Date: July 16, 2020

To: Clinton Harper, General Manager LAWSS

From: Mark Harris, Senior Operations Manager, OCWA

RE: Major Maintenance #20-02 (VFD Floc Mixer Replacement)

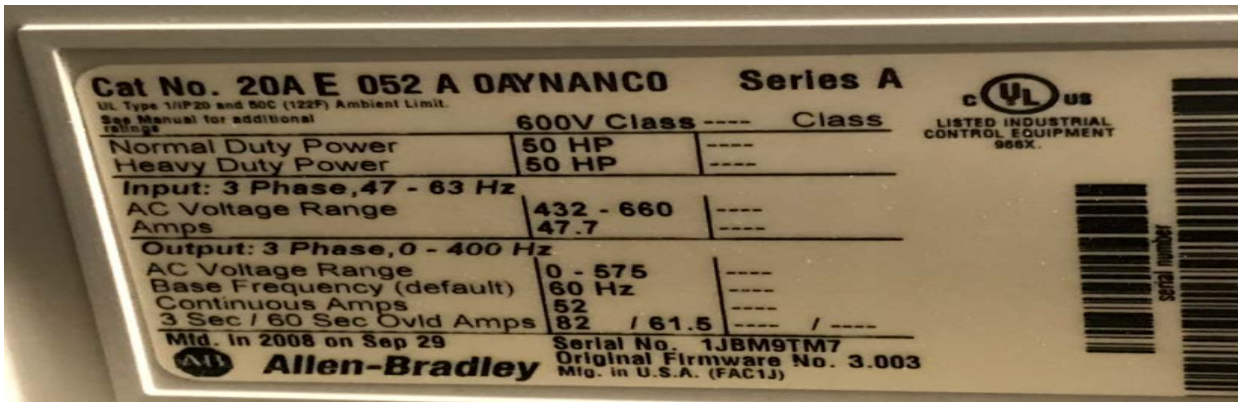
It was proposed that a Major Maintenance Capital Program be initiated in 2020 to start replacing the Floc Mixer VFD's as they were approaching the end of their anticipated life cycle. The picture below details a PowerFlex 70 VFD for Flocculator #3.
